SB, 250 PS, Bar mounting, 2001-05

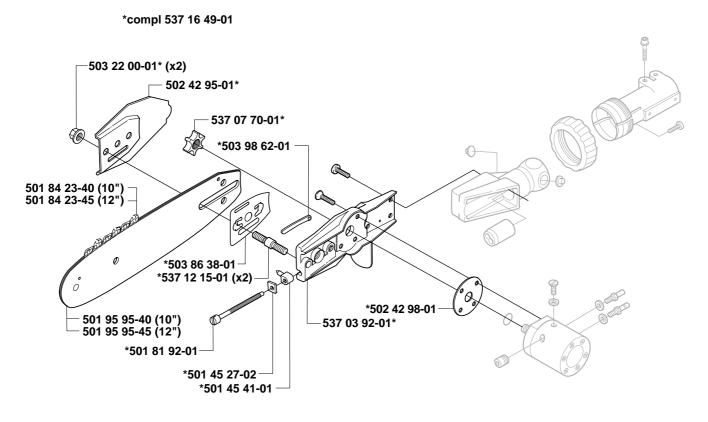
A new bar mounting has been introduced for the pruning saw shaft. This now has the same type of bar mounting as our smaller chain saws. The chain is a 3/8" model 90SG. The pruning saw shaft is supplied as standard with a 10" bar. An optional 12" bar is also available. The new bars operate more reliably and have better lubrication than earlier versions.

New part no.	Description	Excl. part no.	Remark
537 16 49-01	Bar mounting assy.		
537 03 92-01	Bar mounting		
537 12 15-01	Bolt		
502 42 98-01	Gasket		
501 45 41-01	Nut		
501 81 92-01	Chain tensioning screw		
501 45 27-02	Locking nut		
503 98 62-01	Oil seal		
503 86 38-01	Cover plate		
537 07 70-01	Sprocket		
502 42 95-01	Cover		
503 22 00-01	Nut M8		
501 84 23-40	Chain 3/8" 90SG		
501 95 95-40	Bar 10"		
501 84 23-45	Chain 3/8" 90SG		Accessory
501 95 95-45	Bar 12"		Accessory
Introduced from serial numb		011800001	
	953 01 03-01 Shaft 3 m	011800001	
	953 01 04-01 Shaft 4 m	011300009	
	953 01 05-01 Shaft 5 m	011800001	
	953 01 06-01 Shaft 6 m	011000052
